PZ21-00016 (ZC) Planning Comments

PZ21-00016 (DEV)
Chocolatree (Comprehensive)
12/9/21

Letter of Intent - Addendum - Responses
Re Zone of 20 View Dr and 35 Inspirational Dr
Parcel# 408-07-026D

1 Preliminary Parking Signage Plan

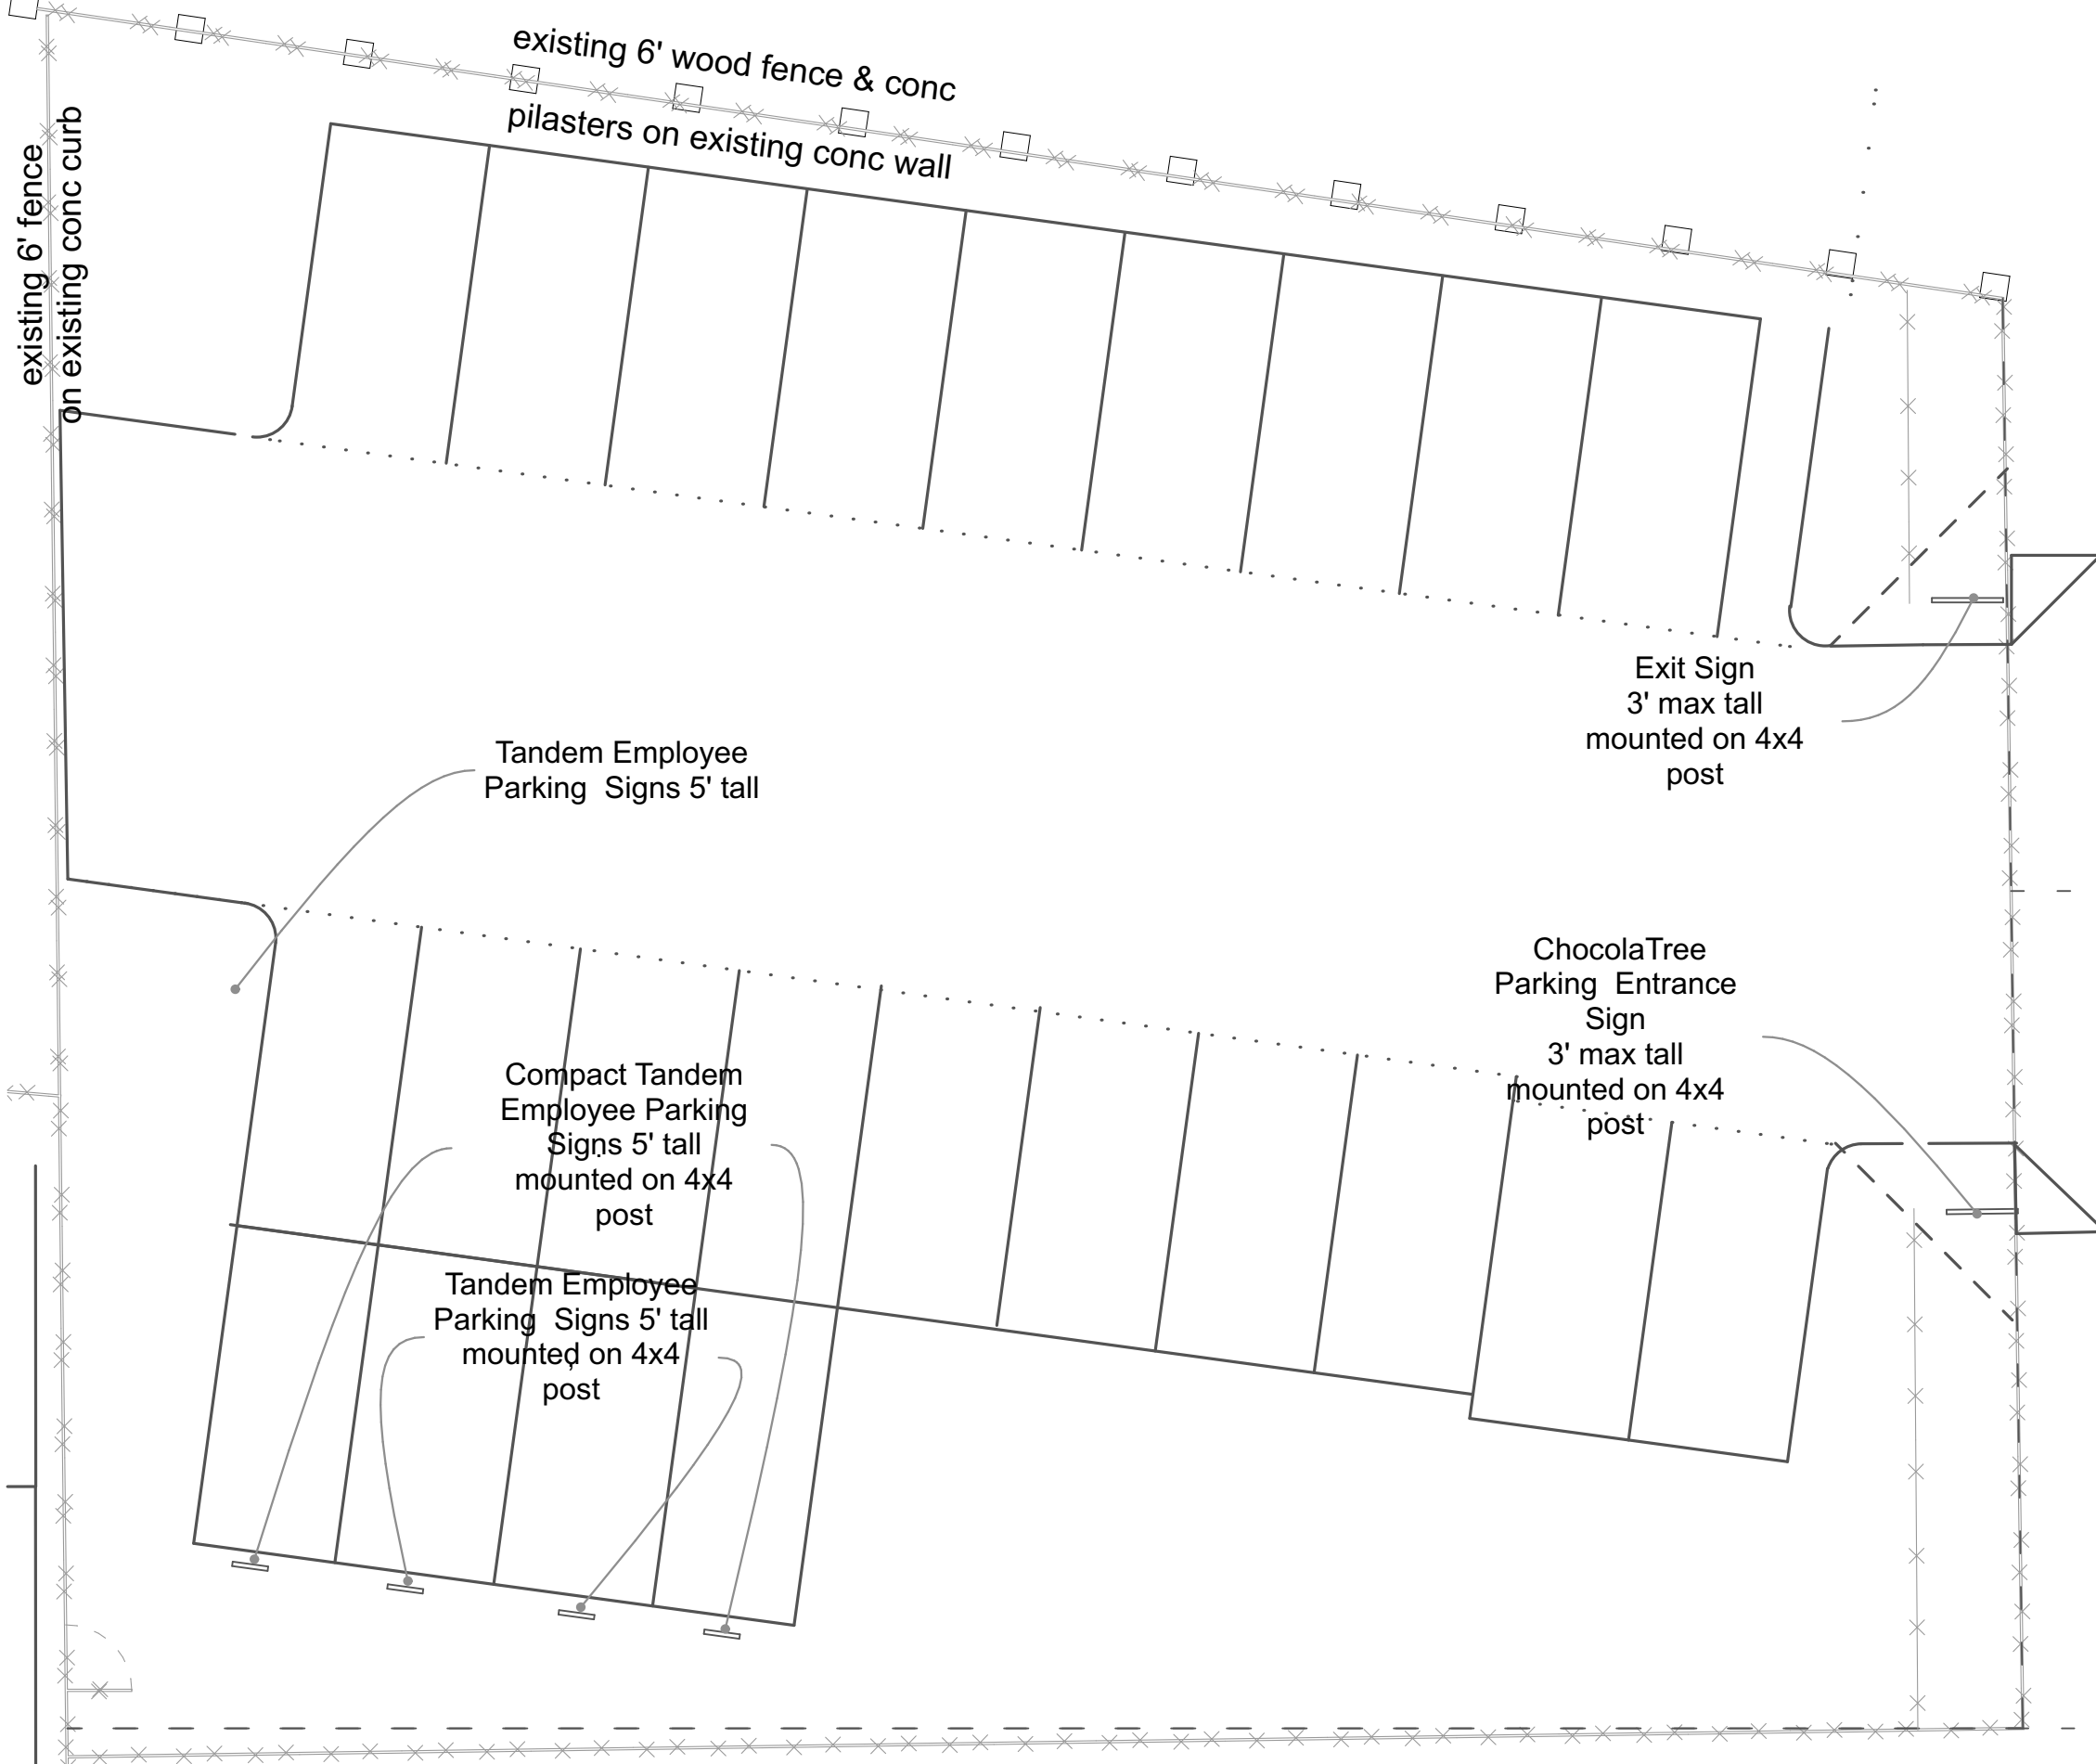
- i) <https://www.sedonaaz.gov/home/showpublisheddocument/44952/637732617633670000>
11. Signs – See LDC Article 6
- a) Provide a color sample for the sign background color.

- b) Provide mounting details and overall height for signs.
 - c) Consider switching the location of the proposed sign, with the entrance sign on the northern side of the driveway and the exit sign on the southern side of the driveway, so it is easily seen by vehicles exiting the site.

11. See attached named “111a.b.c. Preliminary Parking Signage Plan.” The color of sign is white background and dark brown letters, same as ChocolaTree sign but reverse.
